RS-01-175

Dresden Nuclear Power Station, Units 2 and 3
Facility Operating License Nos. DPR-19 and DPR-25
NRC Docket Nos. 50-237 and 50-249

Quad Cities Nuclear Power Station, Units 1 and 2
Facility Operating License Nos. DPR-29 and DPR-30
NRC Docket Nos. 50-254 and 50-265

Subject: Supplement to Request for License Amendment for Power Uprate
Operation

Figure 1
Short Term NPSH Curves

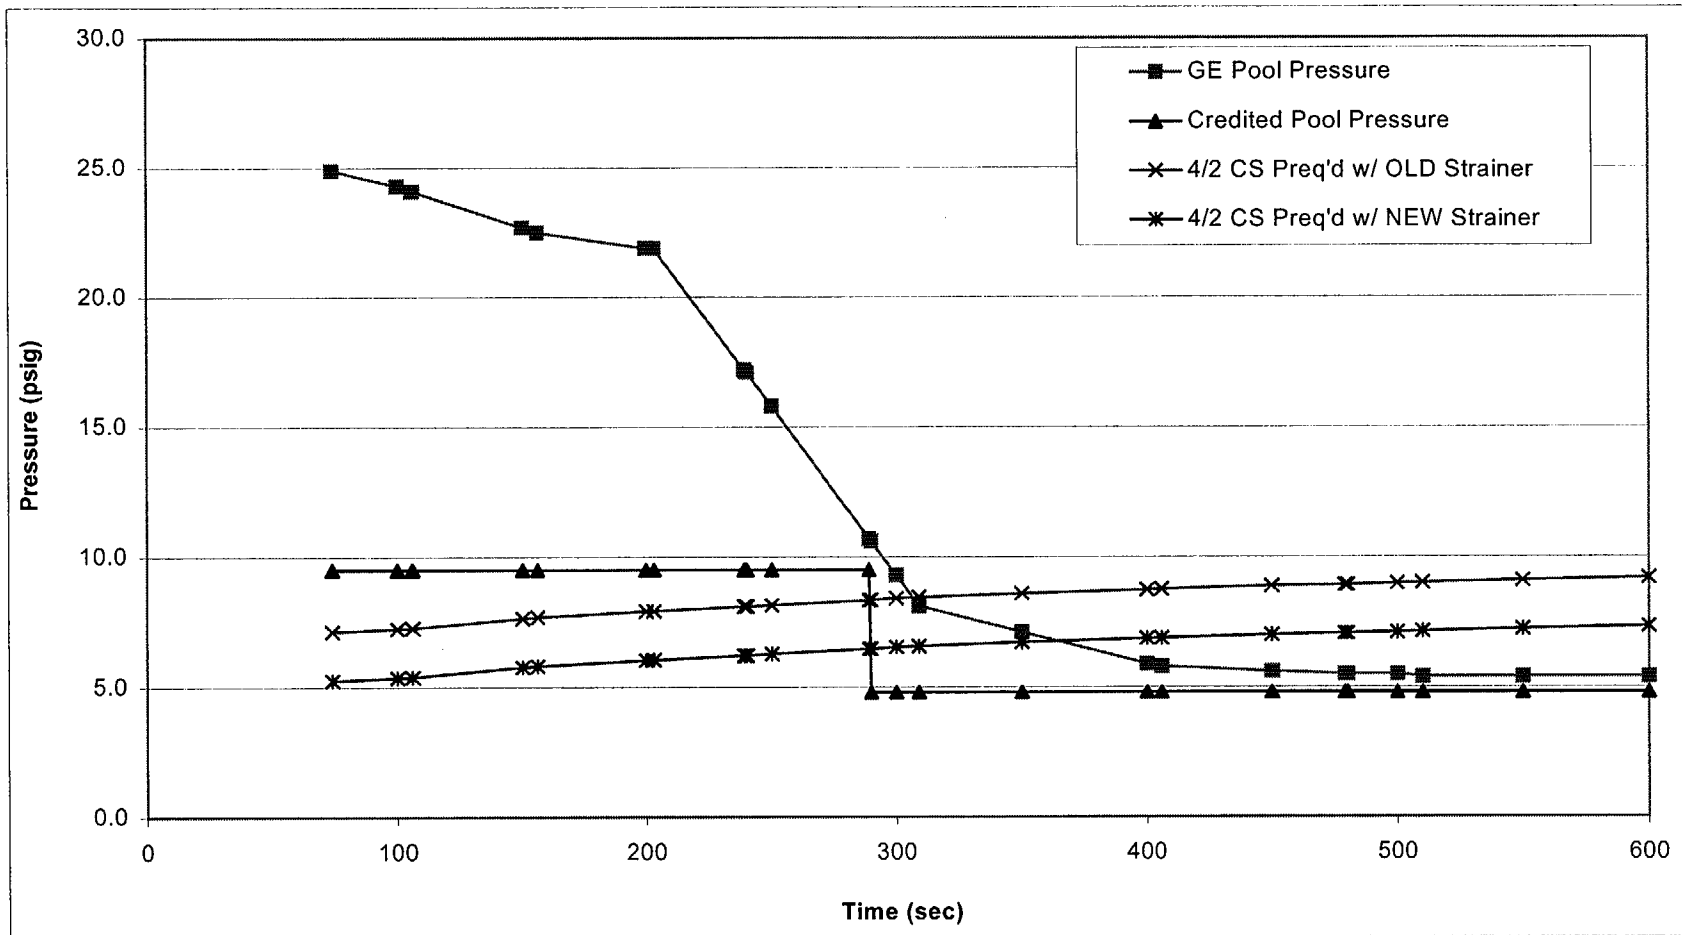
The graphs showing the results of the ECCS NPSH calculations for the limiting short term and long term flow cases are provided in Figures 1 and 2. Core spray flow is the limiting NPSH case in the short term, and LPCI flow is limiting for NPSH in the long term. Figures 1 and 2 also show NPSH required (NPSHr) for both the old strainer and new strainer cases (e.g., one blocked, three clean). The higher head loss of the old strainers, as indicated above, is the basis for the requested overpressure.

In the short term, there is a period from approximately 290 seconds to 600 seconds during which some ECCS pump cavitation may occur, since the available NPSH is less than the required NPSH. This period is after the time at which the peak cladding temperature (PCT) has been reached at approximately 240 seconds. Prior to 290 seconds, the requested overpressure ensures that adequate NPSH is available to meet the core cooling requirements assumed in the PCT calculations. After 600 seconds, ECCS pump throttling restores adequate NPSH. Pump cavitation for the brief time from 290 seconds to 600 seconds is not of concern due to the short duration of the cavitation, as discussed in Reference I.5.

Period	Requested Credit (psi)
0 – 290 sec	9.5
290 - 5,000 sec	4.8
5,000 – 30,000 sec	6.6
30,000 - 40,000 sec	6.0
40,000 - 45,500 sec	5.4
45,500 - 52,500 sec	4.9
52,500 - 60,500 sec	4.4
60,500 - 70,000 sec	3.8

Figure 2
Long Term NPSH Curves

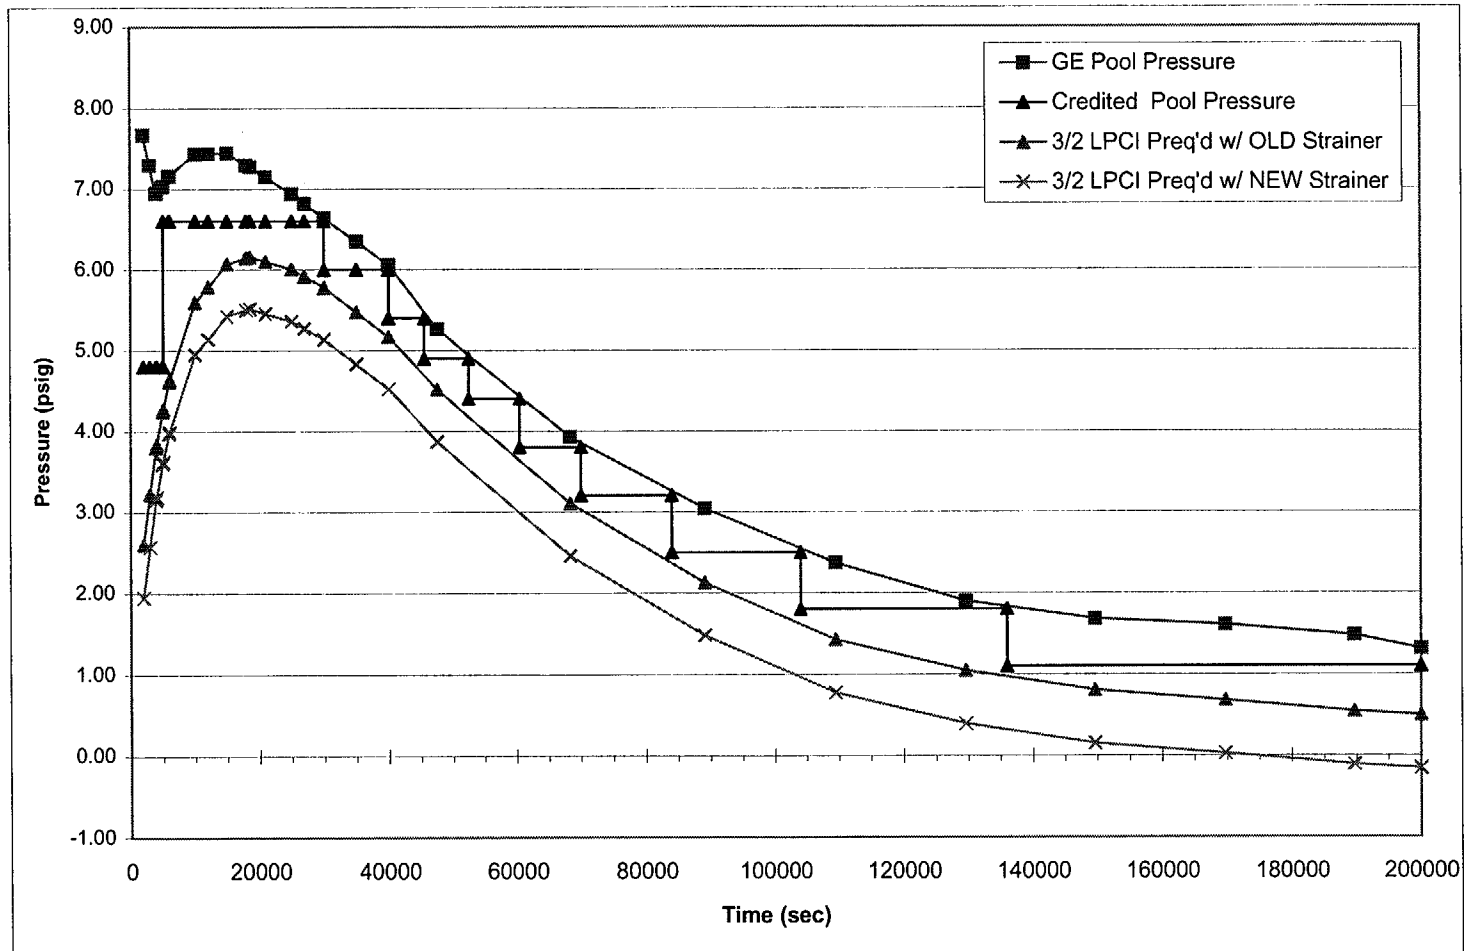
The long term overpressure curves are plotted out to 200,000 seconds. From this point, NPSHa and NPSHr both vary directly as a function of the vapor pressure. The result is that both decrease in parallel fashion, maintaining a margin between available and required NPSH.

70,000 - 84,000 sec	3.2
84,000 - 104,000 sec	2.5
104,000 - 136,000 sec	1.8
136,000 sec – accident end	1.1
